Appendix 2: Consented Scheme - DAS statements fact checked

The analysis of the consented scheme in the developer’s Design and Access Statement (Section 4.2) is misleading and seems a deliberate attempt to justify ignoring both the scheme and the views of the local community who support it. The finger blocks are particularly important since these are retained to form the basis of the SNB community group’s alternative plan (Appendix 3). The following appendix investigates claims made by the developer in the DAS.

Consented scheme (right)

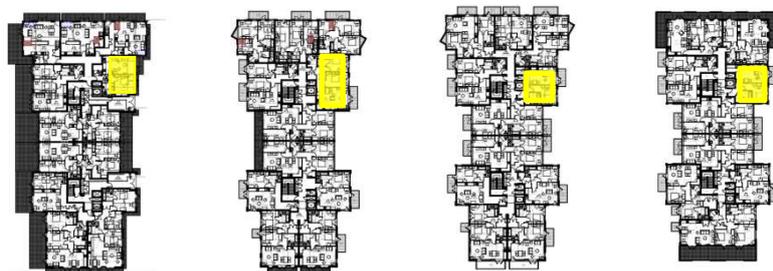
This inaccurately shows large areas of what the developer believes to be north facing flats, highlighted in yellow. Only one floor plan has been used – whereas, in fact, floor plans vary and step back on higher floors. 75% of the highlighted area is actually showing dual aspect flats, not single aspect.

These show that there are actually only four North facing flats/block (shaded yellow)

Flats in North Finchley (left)

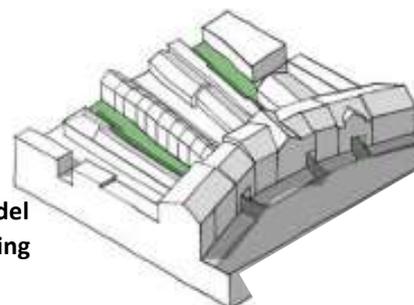
Reality: the current proposal is not a recognized suburban form. Indeed, the DAS elsewhere claims that this is an urban (rather than suburban) site in order to justify high densities. The argument lacks consistency and rigour, as does the proposed design

This statement is subjective and misleading. However, it presupposes that buildings on this site *should* be suburban in form – even though the developer seems intent on justifying an ‘urban’ scheme.

It is not uncommon to build perpendicular to a road. A good example is the three storey 30s flat block in North Finchley (below). In fact, with the wider ‘front’ part addressing the road, it is very similar to blocks in the consented scheme.

Consented scheme: Block A and part of the basement plan

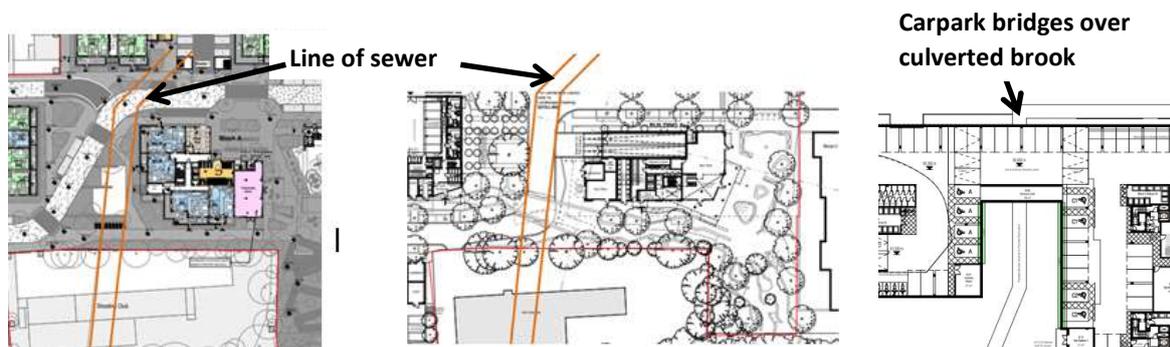
This statement is inaccurate and misleading: the architects for the consented scheme took full account of below ground site constraints as noted in their DAS:

- Block B is designed so that there are no footings over the easement. At ground floor, this is a parking area.
- Block A floorplate fits nicely between the sewer and the culvert to Pymmes Brook (below). The original underground carpark proposal bridged over the culvert to access the main parking area beneath the finger blocks. Omitting this represents a cost saving for the developer but has a detrimental effect on the design.

The basement plan (far right) shows that a bridge over the culvert to Pymmes Brook was originally proposed to connect parking under Block A with the main area.

COMPARISON OF LANDSCAPING IN THE CONSENTED AND PROPOSED SCHEMES

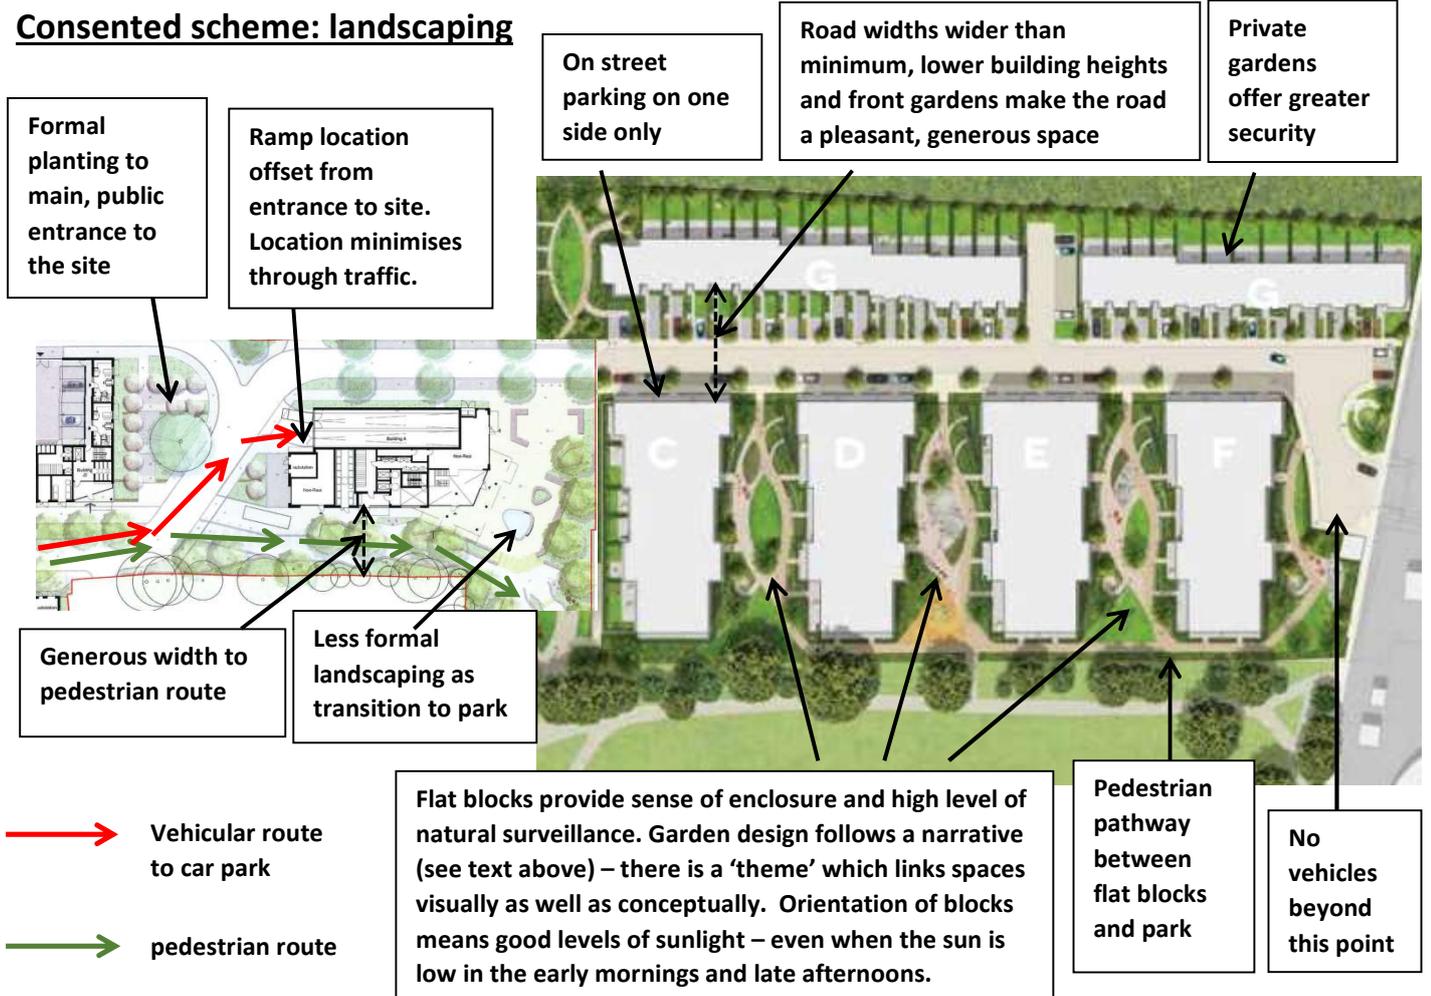
This statement is subjective and misleading. As discussed (no.10 above), the hierarchy of public and private spaces in the consented scheme has been much more carefully thought through, from a more formal public square at the entrance of the site, through increasingly informal landscaping on the public pedestrian route (Pymmes Square) and in the semi private gardens between finger blocks. Houses along the western boundary have their own private gardens, increasing security in this area.

By contrast, the lack of definition between public and private is one of the main design issues in the proposed scheme, the result of a flawed layout strategy (see Section 5 in the main report). This has also been commented on by the GLA (see Appendix 1). Left-over spaces between blocks are utilised for parking, playgrounds, communal gardens, turning heads for vehicles or ramped access to the basement carpark. There is little evidence of place making or hierarchy of public and private in the external spaces in this scheme.
